VALIDATION/VERIFICATION REPORT

ACR VALIDATION/VERIFICATION OF THE ROSETTA IFM PROJECT (ACR878)

REPORTING PERIOD 1

Project Name	Rosetta IFM Project
Project ID	ACR878
Reporting Period	1/1/2023 – 4/30/2023
Client	Weyerhaeuser Company
Date of Issue	11/6/2024
Prepared By	S&A Carbon, LLC
Contact	705 SE 55 th Ave Portland, OR 97215 www.saacarbon.com
Audit Team	Lead Validator/Verifier: Bill Stack Lead Validator/Verifier (under observation): David deRoulhac Technical Reviewer: Pablo Reed Biometrician: Elizabeth McGarrigle Technical Expert: Marty Duffany & Stacy Birch (under observation) Site Visit Team: Bill Stack (RPF), David deRoulhac & Stacy Birch Project Manager/Approver: Alexa Kandarís

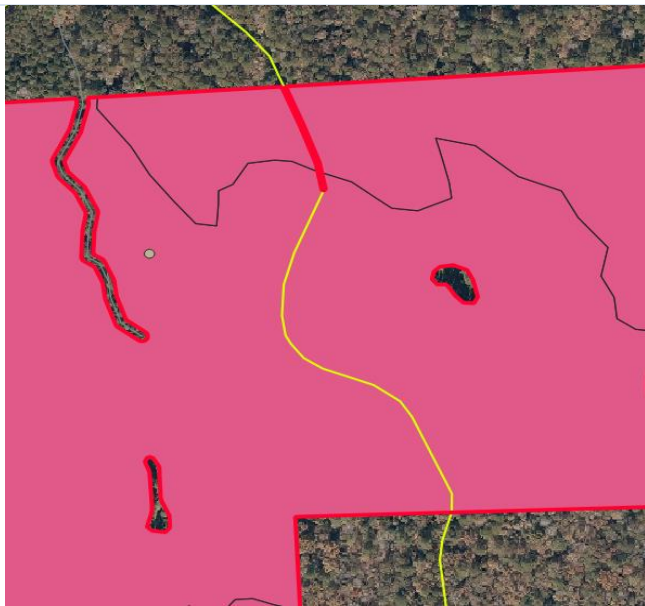
Another example of public roads being included in the project area is Dry Fork Road, near plot 282 and State Highway 28 north of plot 298 that have been included in non-productive strata.

Verifiers understanding, based on previous verification projects, is (a) roads that are excluded from the sampling frame should be excluded from the project area and associated total project acreage; and (b) all roads not owned by the PP such as public roads should be removed from the project area and excluded from non-productive strata as those entities are not listed as a project proponent.

Please review and revise as appropriate to clarify the road delineation methods including any criteria used to include/exclude roads from the project area and/or to justify the inclusion of roads not within the sampling frame that are being included in the project area.	
			<p><u>October 9, 2023 Findings</u></p> <p>(1) Verifiers understand the road right-of-way (ROW) width designations are made at the local level by planning/road foresters. Many of the previous noted project boundary overlaps of the ROWs have been removed in the revised spatial data. However, through spot checks of the revised spatial data, verifiers still observe some overlaps of project strata/area onto these ROWs. For example, northeast of plot 72, Serepta Rd. Here, the ROW is included within the project area and appears to not be adequately buffered. Another example exists along Macedonia Rd., east of plot 278 approximately 750'. Verifiers understand some minor ROW overlaps (<1 acre) exist along project boundaries and edges depending on aerial imagery quality and projection. Verifiers are requesting the more significant ROW discrepancies be reviewed and revised as these tend to overestimate the project area and the associated project stocks. Please review the external/public road ROW overlaps, and revise and/or clarify as appropriate. Also, please update the Rosetta Inventory SOP to include road width classifications and road identification types to clarify the road delineation process.</p> <p>(2) Verifiers understand that many external roads and non-productive areas have been removed from the sampling frame and the revised project area (<i>Rosetta_StandsAndStrata_NoNP_Updated7192023</i>). Verifiers appreciate the efforts made by WY to remove all non-productive areas and external roads.</p> <p>However, verifiers are still observing some public roads within the project area that we believe should be removed from the project area. Some examples include: Willie Neyland Road, a local road immediately south of Plot 157; Hiram McGraw rd, a local, paved road, East of plot 323; and Bruce Road. There are likely other existing external roads still in the project area. Please review and revise/clarify as appropriate.</p>	<p><i>Rosetta_StandsAndStrata_NoNP_Update d7192023</i></p> <p><i>Rosetta_WYExternal_Roads.zip</i></p> <p><i>Rosetta_PlotLocations_AllCombined</i></p>

<p><u>December 6, Findings</u></p> <p>(1) Verifiers appreciate the efforts of the PP to remove roads from the Rosetta project area. Verifiers confirm that PP has provided updates to the Rosetta Inventory SOP (1.2, Pg. 2) that include a description of road width classifications and road id types. This issue item is closed.</p> <p>(2) Verifiers continued spot checks of roads within the updated project area and strata files (<i>Rosetta_StandsAndStrata_NoNP_Updated 11162023</i>) provided by the PP. Verifiers clipped the external road layer (<i>Rosetta_WY_External_Roads</i>) to the project area and though there are many minor/insignificant overlaps,</p>	<p><i>Rosetta_StandsAndStrata_NoNP_Update d11162023</i></p> <p><i>Rosetta_WY_External_Roads.shp</i></p> <p><i>RosettaInventorySOP12012023</i></p>

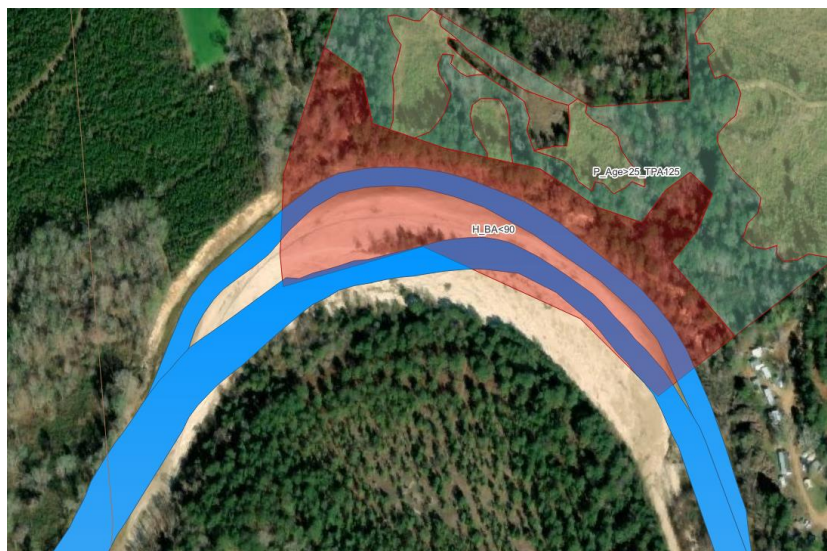
<p>determining measured plot origin is not correct, please provide an updated "ORIGINALPlots_Albers" layer that includes the final Plot_ID.</p> <p>3.) For plots with a Plot Action of "Moved" what criteria was used to determine distance and angle of move. Was any randomness introduced in the field when the plots were offset into an unharvested strata?</p> <p>4.) How were the locations of plots with a Plot Action of "Replacement Plot" chosen? Verifiers were unable to tie these plots to the Rosetta_ORIGINALPlots_Albers.shp points indicating that they were not in the original allocation. Please provide any supporting files that may have been generated from the allocation of replacement plots.</p>	
		<p><u>October 4, 2023 Findings</u></p> <p>1.) Plot 216: The latest Plot Move Explainer spreadsheet indicates the following information "<i>In Final Plot List: No, Comments: Updated strata on plot to reflect second thinning harvest that occurred prior to cruise measurement. To ensure original strata maintained desired sampling intensity, plot 319 was added to take its place in the originally designated strata.</i>" The latest combined GIS and calculation files indicate that this plot was retained in the P_Age=20to22_TPA125 strata while initially assessed to be P_Age=20to22_TH185. Please clarify why the plot was kept when indicated that it should not be in the final plot list.</p> <p>2.) Verifiers were able to confirm that all moved plots were removed from the inventory. This is further described in the Inventory SOP. This issue item is closed.</p> <p>3.) Verifiers acknowledge that all moved plots were removed from the inventory. This is further described in the Inventory SOP. This issue item is closed.</p> <p>4.) Verifiers confirmed that replacement plots installed in the initial inventory were removed from the inventory. This issue item is closed.</p>	<p><i>Plot_Move_Explainer_IncludeAllPlots_Updated09122023.xlsx.</i></p> <p><i>Rosetta_PlotLocations_ALLCombined.shp</i></p> <p><i>RosettaInventorySOP20230919.pdf</i></p>

<p><u>December 6, 2023 Findings</u></p> <p>1.) Plot 216 was confirmed to have an "<i>In Final Plot List</i>" = Yes in the Plot Move Explainer workbook. This aligns with its use in the carbon calculations for the project. The strata change made to this plot will be further reviewed under Issue 23-12. This issue is closed.</p>	<p><i>Plot_Move_Explainer_12012023.xlsx</i></p>
PP Response			
Date	PP Comment	Additional evidence submitted for review by PP

8-Sept-23	<ol style="list-style-type: none"> 1. Clarification added to Plot Move Explainer as to why plot 216 was retained. 2. Plots identified in this finding are to be dropped along with all offset plots as mentioned in finding 23-6 3. Plots identified in this finding are to be dropped along with all offset plots as mentioned in finding 23-6 4. All replacement plots are to be dropped along with offset plots. 	Plot_Move_Explainer_IncludeAllPlots_Update d08292023.xlsx
1-Dec-23	<ol style="list-style-type: none"> 1. In the case of this plot, the "in final plot list" column was not properly updated for this plot, it should say "in final plot list = Yes". As referenced in finding 23-12 this plot to reflect thinning activity that occurred on the stand prior to cruise measurement and should have been updated previously. 	Plot_Move_Explainer_12012023.xlsx
